**Re: Permit Number M-2004-031 – Hazeltine Mine  
Technical Revision TR-04 – Adequacy Review Response**

Aggregate Industries (AI) submits this letter in response to the Division's May 21, 2015 preliminary adequacy review of AI's TR-04 request with regard to a temporary mitigation plan.

SCHWARZ PARCEL

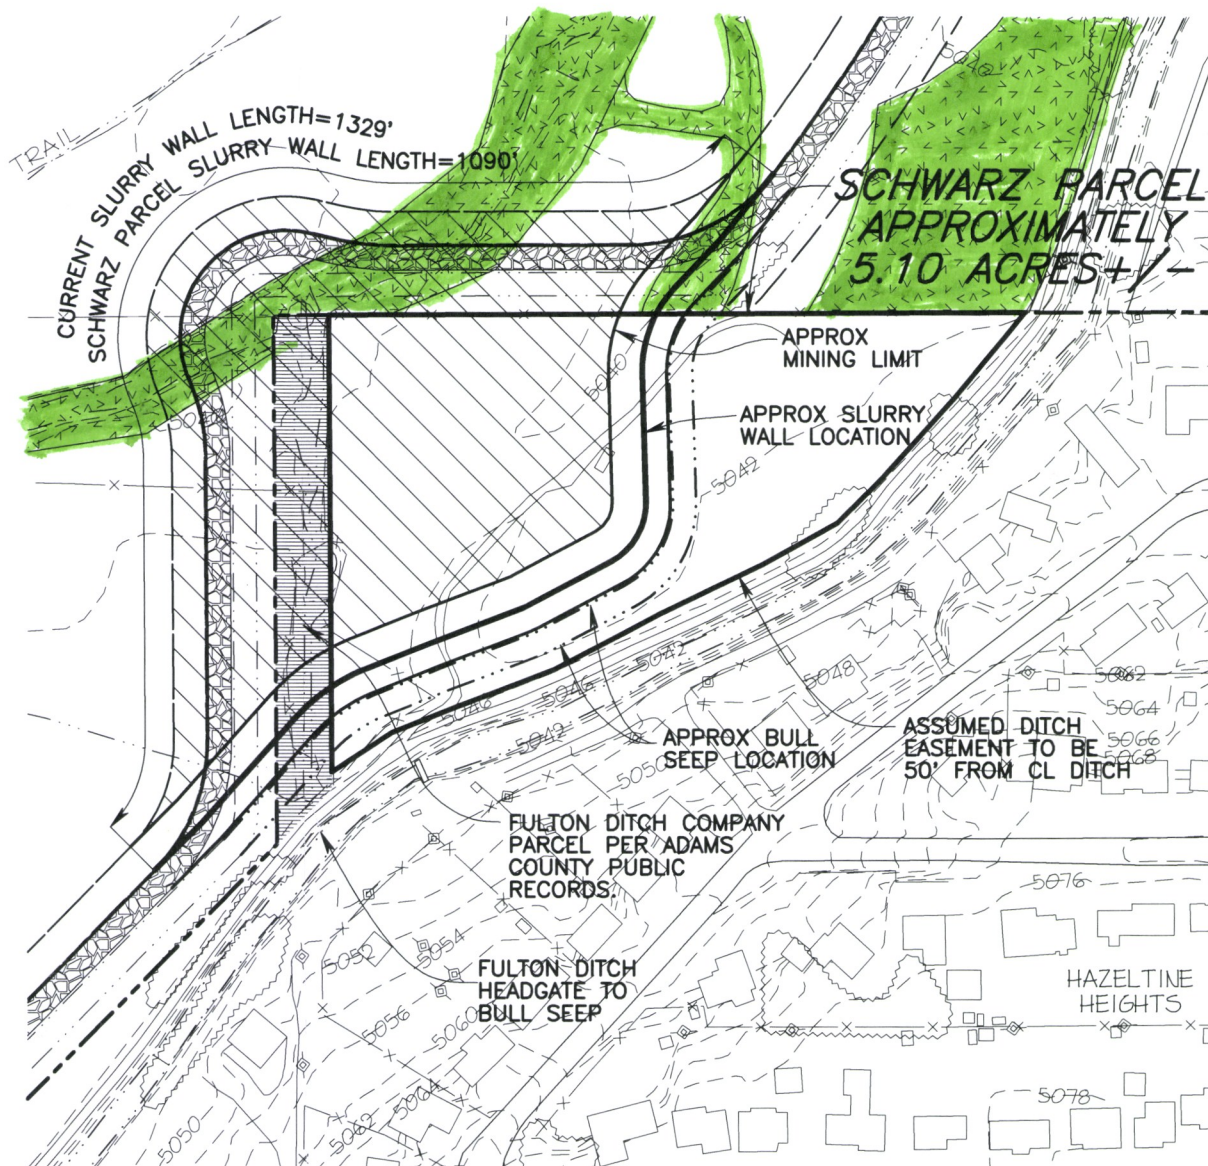
- AI had investigated the possibility of incorporating this parcel into its permit boundary. Please see enclosed e-mails and referenced attachments between Karen Flanders of Tetra Tech and Blair Cooley of AI between March 17 and April 1, 2004 and note that areas highlighted in green on the figure are jurisdictional wetlands

delineated on AI's property. A delineation was not done on the Schwartz parcel since AI determined not to pursue incorporation of the parcel following a subsurface conditions evaluation.

HAZELTINE PIT  
SUMMARY LOGS OF  
EXPLORATORY BORINGS

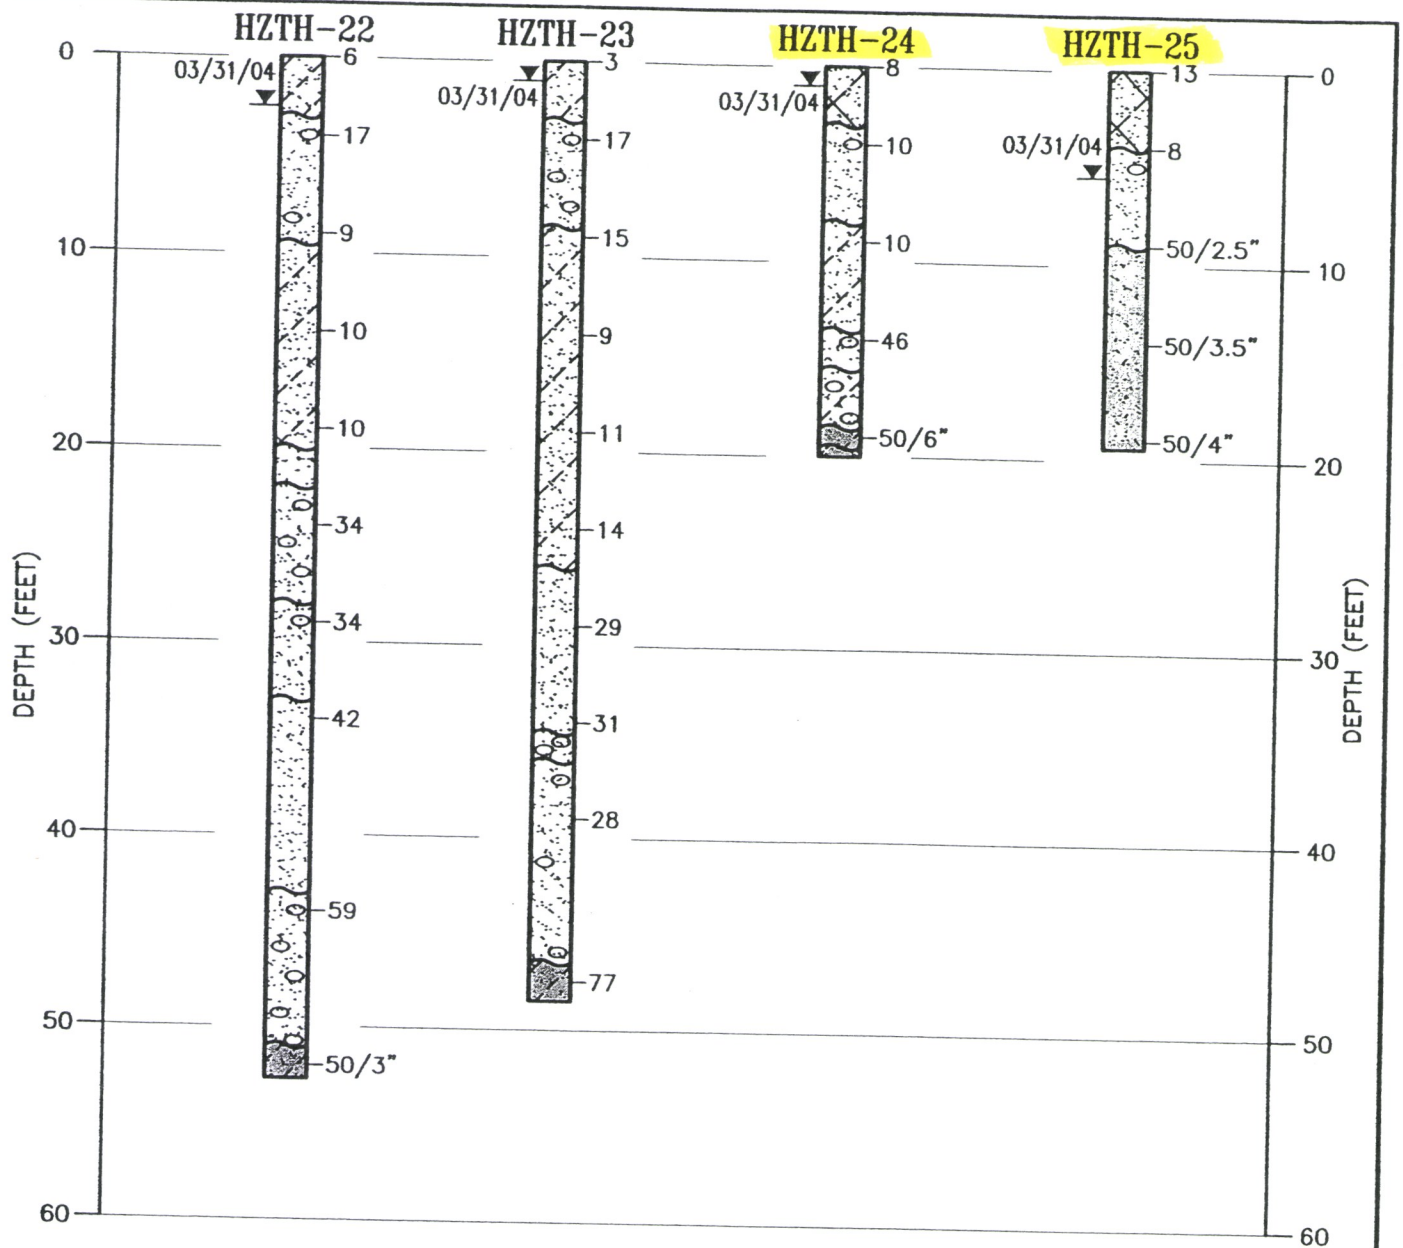
- Two test holes were drilled on the property in March 2004. These holes are labeled HZTH-24 and HZTH-25 and highlighted on the Existing Conditions Map. A copy of the map and the drill logs that contain the information for those test holes is enclosed. The logs show that groundwater level at HZTH-24 was approximately 1-foot below ground surface and at HZTH-25 was approximately 5 feet below ground surface on March 31, 2004. Assuming that water levels at these test hole locations would have been similar to those at HZMW-2, which had increased approximately 3 feet from the previous year, there would have been standing water in the vicinity of HZTH-24 and water level at HZTH-25 would have been within 2 feet of the ground surface.

Based upon the above information, it is AI's position that the 5040.78 foot invert elevation proposed for the two (2) 18-inch pipes, with drain gates set to provide maximum drainage, will achieve the initial goal of the temporary mitigation plan, which is to draw down water levels from the adjacent Orr property as quickly as possible. As stated in AI's TR request, water will be pumped if necessary to achieve the initial goal of the temporary plan.
